SERVICE BULLETIN

SB98.3

Machines/Models: X31, X32 ONLY

PURPOSE: To reduce scissor brace end play.

Figure 1

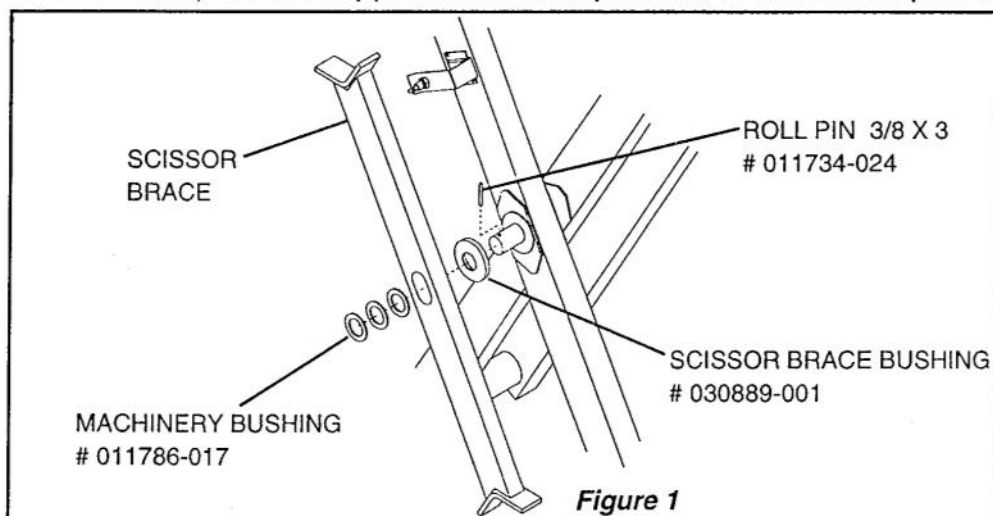
OPERATION REQUIRED: Install Scissor Brace Bushing and Shims.

2. Remove roll pin using a hammer and roll pin punch. **NOTE: Always use proper eye protection when removing or installing roll pin.**
3. Remove scissor brace and existing shim.
3. Install Scissor Brace Bushing (#030889-001) with chamfered edge towards scissor arm.
4. Install scissor brace.
5. Install shims as needed to achieve minimum amount of end play.
6. Install roll pin and return scissor brace to its locked stowed position.
7. Remove overhead platform support and return platform to its stowed position.
